ACRS-1718

MEETING MINUTES OF THE COMBINED
ACRS ECCS/REACTOR FUEL SUBCOMMITTEE MEETING
FEBRUARY 14, 1980
WASHINGTON, D. C.

On February 14, 1980 the Combined ACRS ECCS/Reactor Fuel Subcommittee met in Washington, D.C., to discuss the effects of externally mounted thermocouples on the LOFT fuel rods, and proposed changes in the ECCS fuel cladding rupture models for Appendix K to 10 CFR 50.46, and the effect of these changes on vendor's evaluation models. The notice of the meeting appeared in the Federal Register on January 30, 1980. There were no requests for oral or written statements from members of the public and none were made at the meeting. Attachment A is a copy of the meeting agenda. The attendees list is Attachment B. Attachment C is a tentative schedule of presentations for the meeting. Selected slides and handouts from the meeting are Attachment D to these minutes. A complete set of slides and handouts is attached to the office copy of these minutes.

TC-1 BLOWDOWN PEAK TEMPERATURES

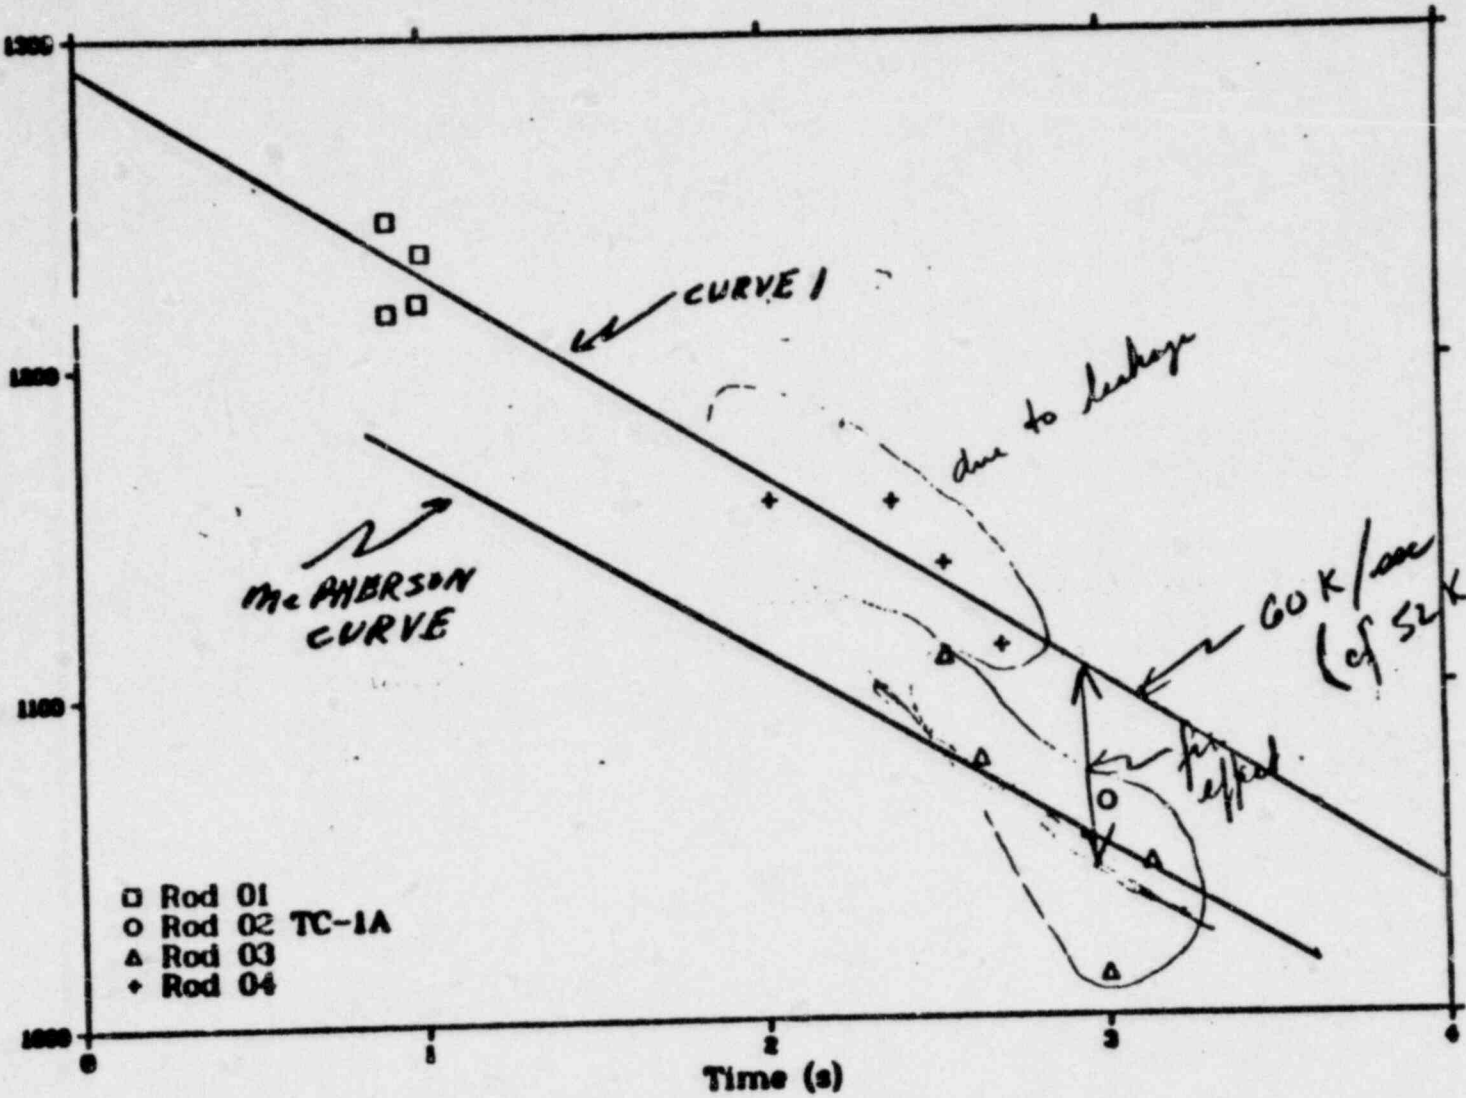
- The tests showed a definite fin effect during film boiling (Figure D-4). Dr. McPherson said this result and others can be used to estimate the magnitude of the effect.
- Dr. McPherson showed a data plot for the TC-1 blowdown peak temperatures. A best fit curve (Figure D-5 curve 1) was drawn through the data for the rods with internal thermocouples. The slope of the curve was given as $60^{\circ}\text{K per/sec}$. Dr. McPherson said that this meant that delaying DNB will raise the PCT by $60^{\circ}\text{K per/sec}$. Based on data results from the external thermocouple rods, Dr. McPherson suggested one could draw a parallel curve (labeled McPherson curve on Figure D-5) that illustrates the fin

effect. Dr. Lienhard questioned the positioning of this curve given the data scatter, and the fact that there were no data points on the upper portion of the curve.

TC-IC REFLOOD INTERNAL TEMPS

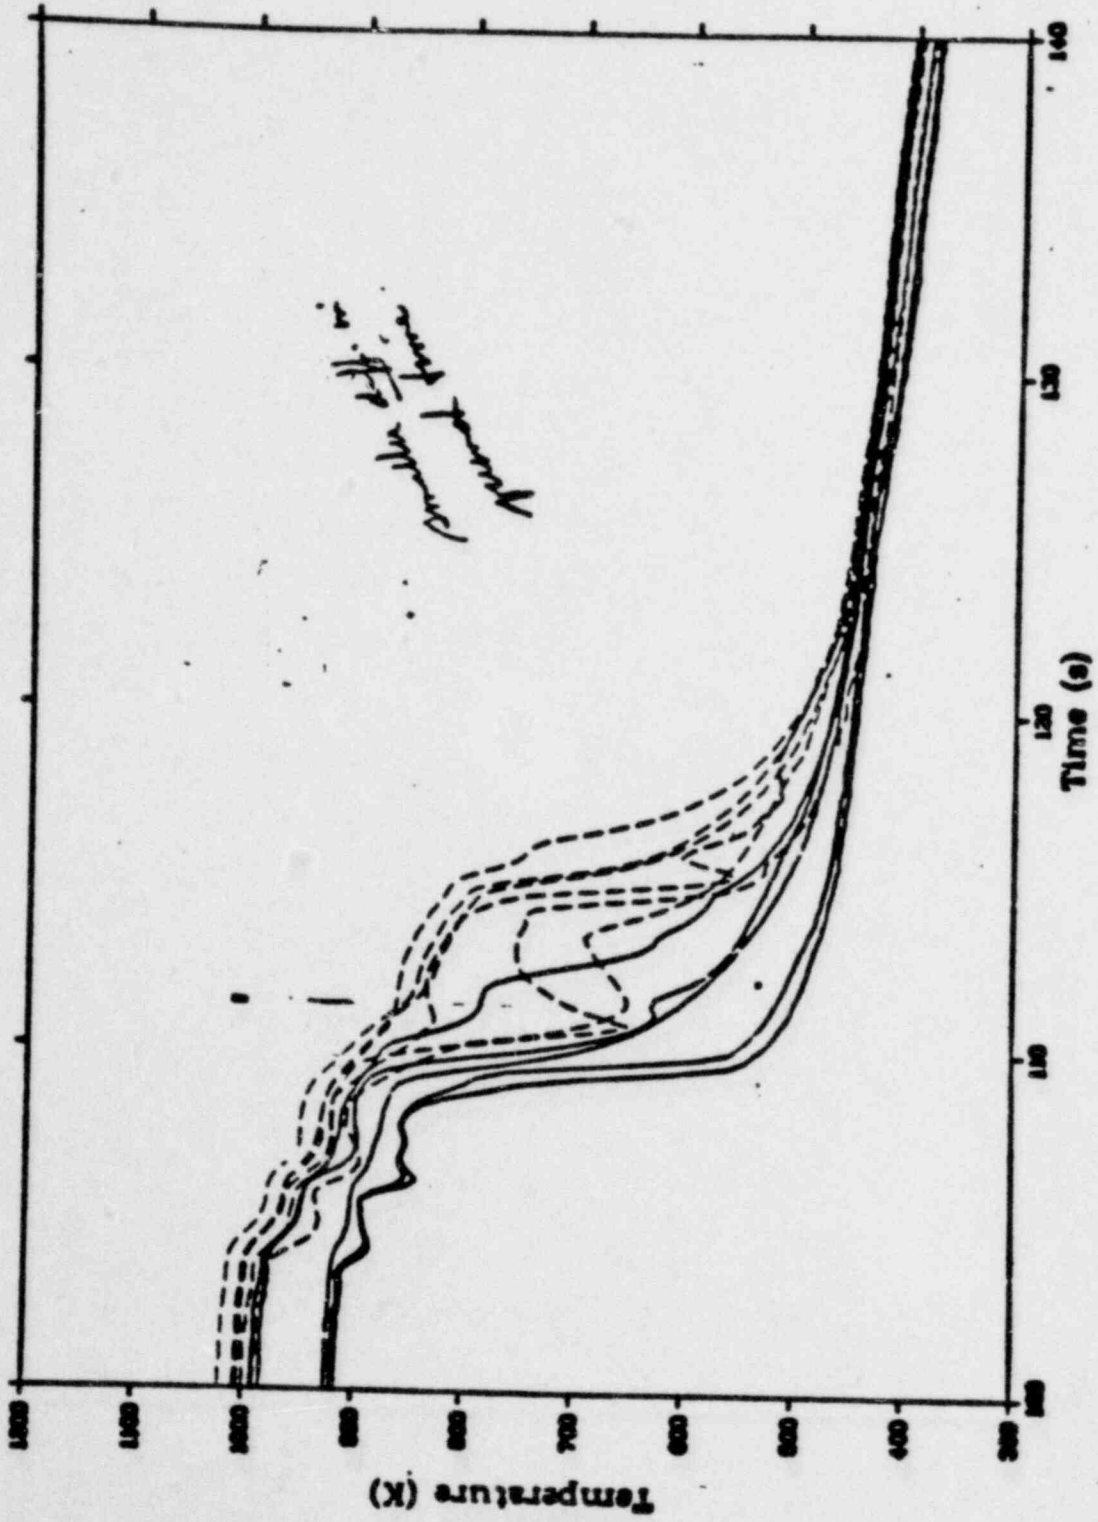
- Concerning the reflood portion of the TC-1 experiment, Dr. McPherson noted that all the rod temperatures begin to decrease about the same time, whether or not they had external thermocouples (Figure D-6).

SLOW-RAMP BURST STRAIN CURVES

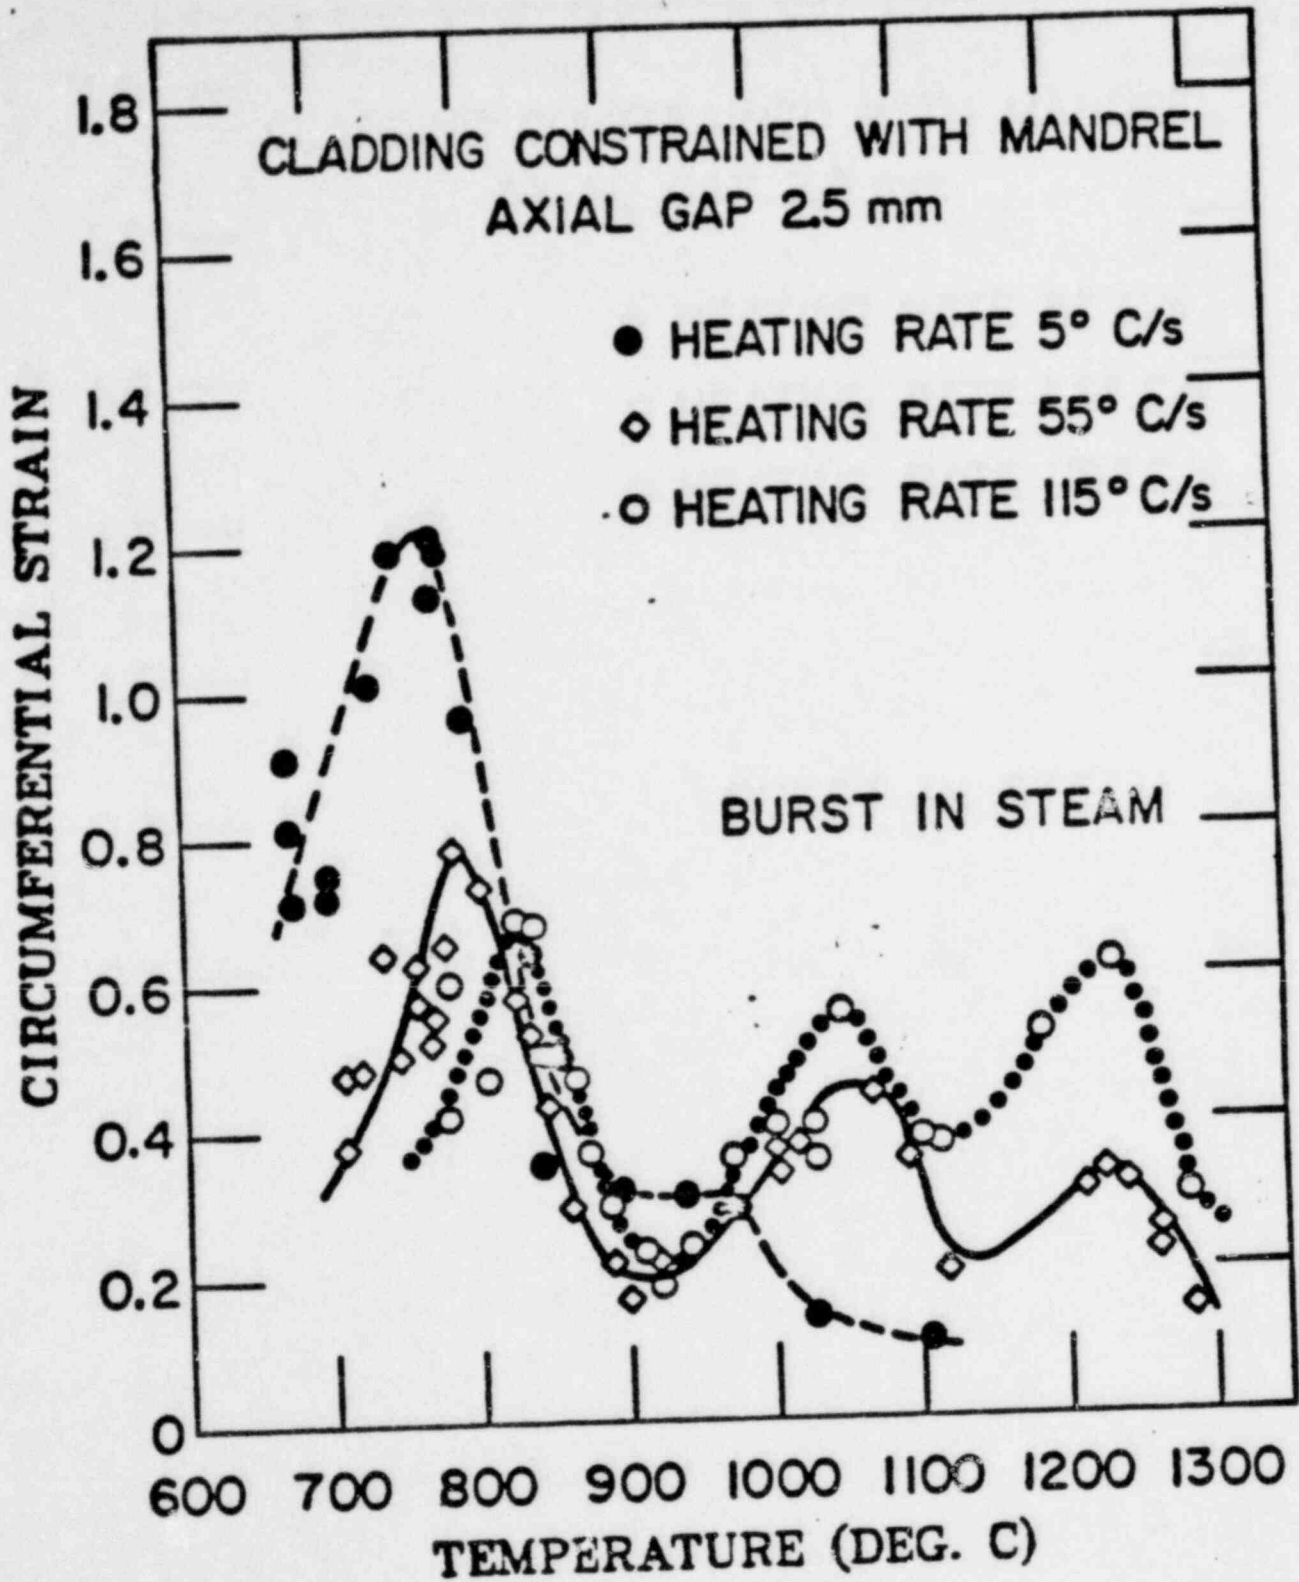
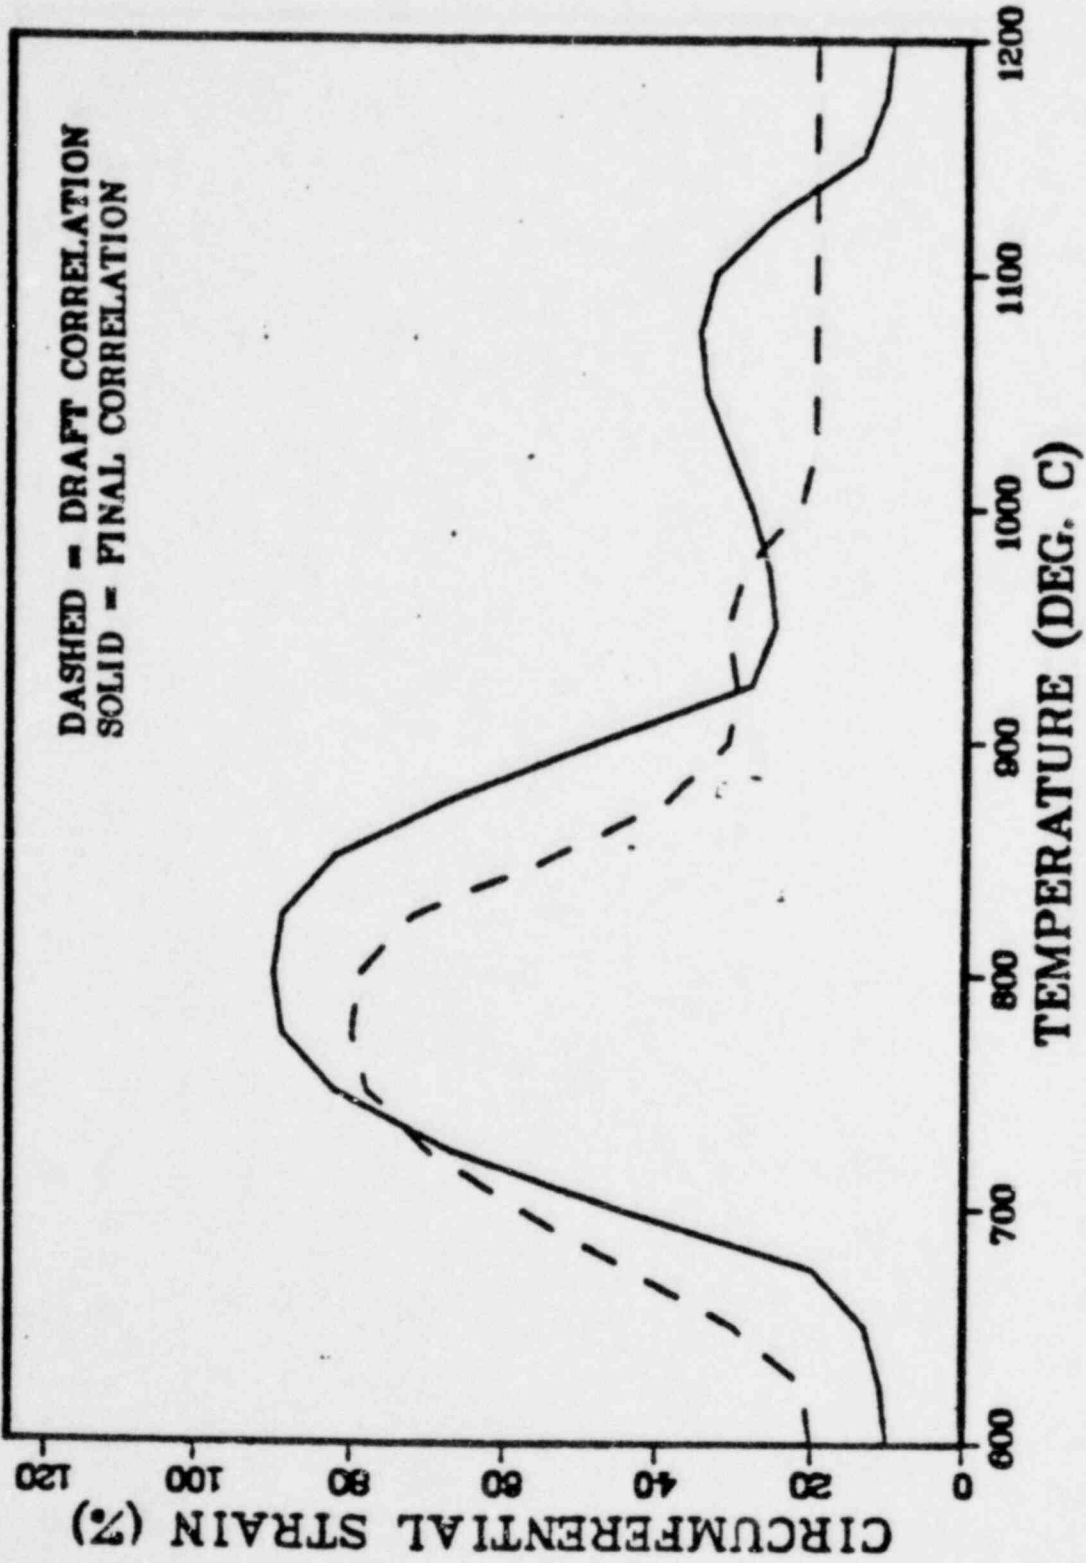
Dr. Powers noted that the slow and fast-ramp burst strain curves have been modified from the initially developed correlation, largely at the recommendation of Dr. Chapman from ORNL (Figures D-14A-15). There was considerable discussion over the applicability of the data used to develop the high temperature portion of the fast-ramp burst strain curve (Figure D-15-arrow). These data were taken from the Oak Ridge tests; however, in response to a question from Dr. Shewmon, Dr. Chapman of ORNL expressed doubt that this data should be characterized as fast-ramp data, due to problems encountered during the experiment. Dr. Shewmon observed that there appears to be a dubious basis for the development of that portion of the curve.

Ass. No 7807

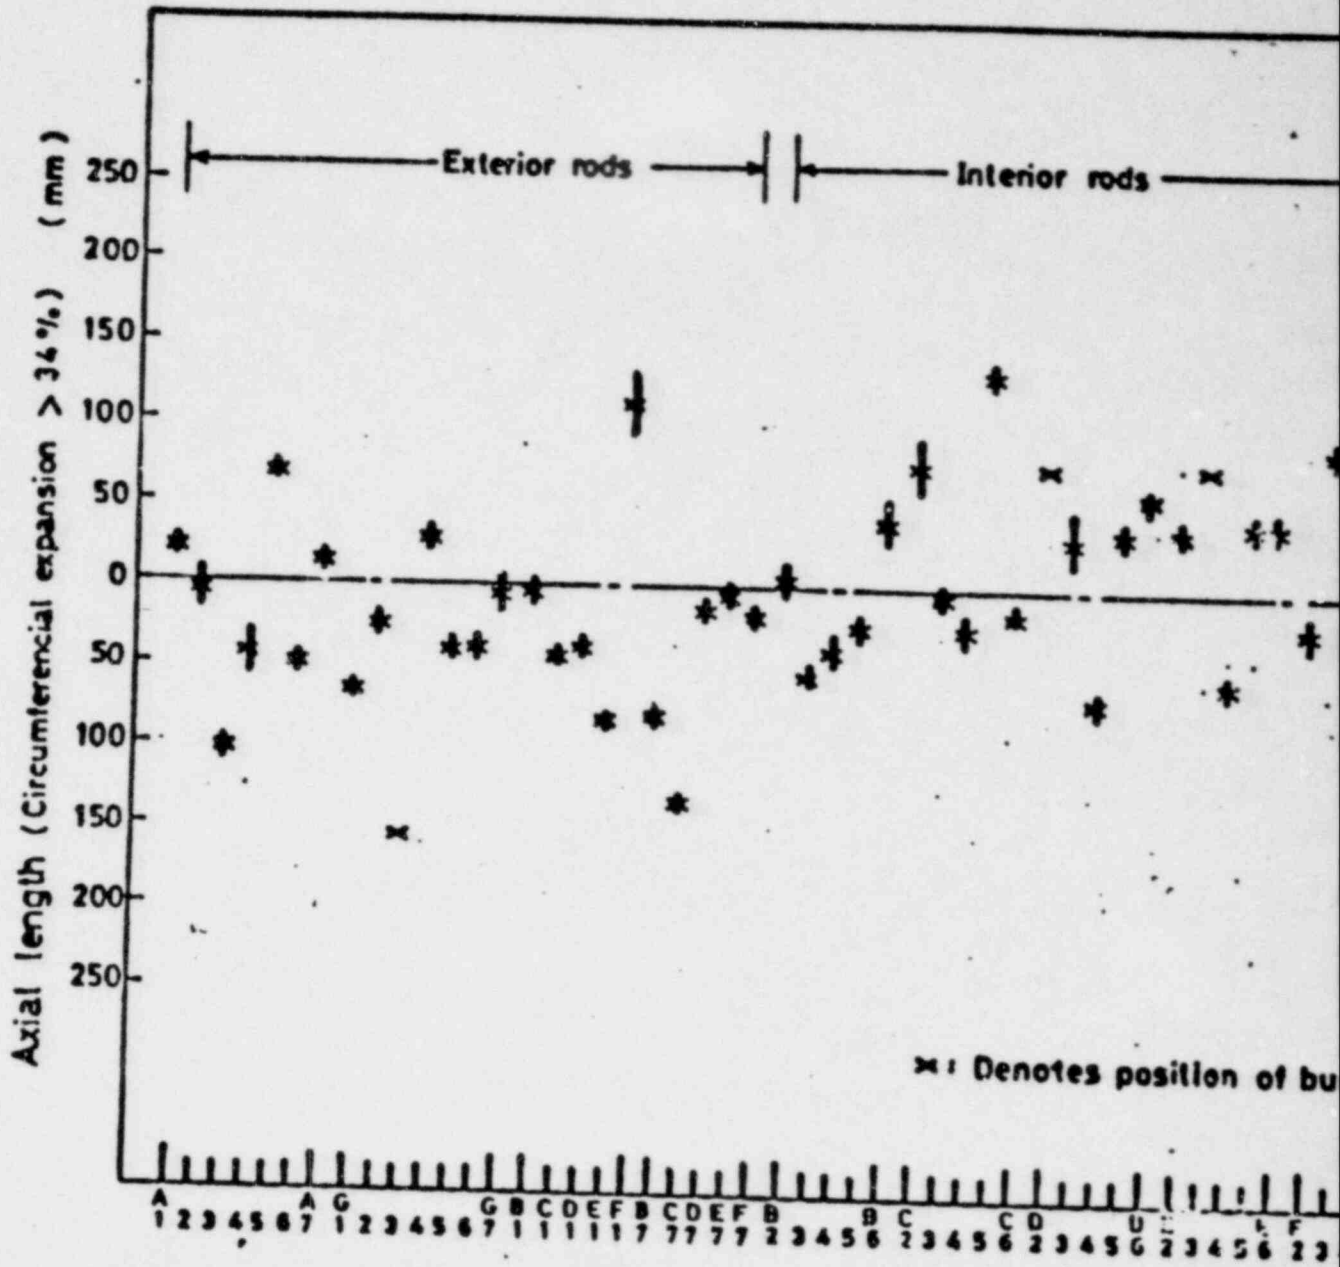
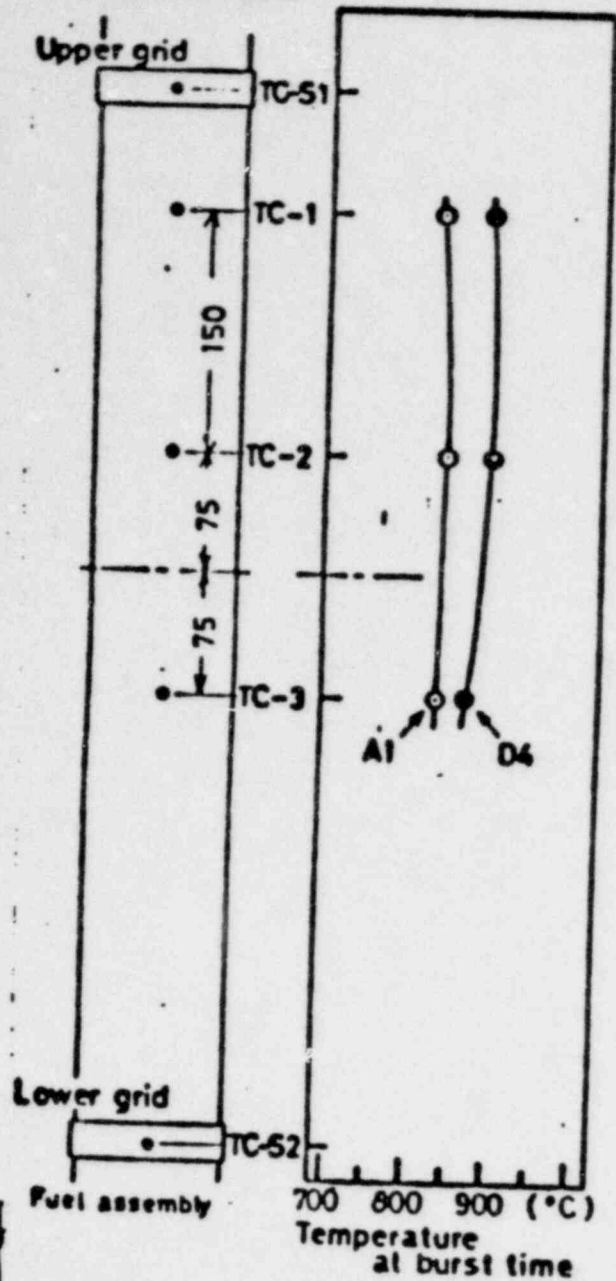
In describing the flow blockage correlations, Mr. Burman referenced some Japanese multi-rod burst tests that resulted in a large degree of co-planar blockage (Figures D-22-23). Mr. Burman said he believed this co-planar blockage was the result of the tungsten wire electrical heating element used (Figure D-24). (Note: Dr. Kawasaki was contacted by NRC concerning Mr. Burman statement regarding cause of the co-planar blockage. Dr. Kawasaki said that he does not believe the heater design was the cause of the co-planar blockage.

Rather it was probably due to effect of the steam flow and/or the grid spacers used in the experiment.) Westinghouse believes their flow blockage model is sufficiently conservative.
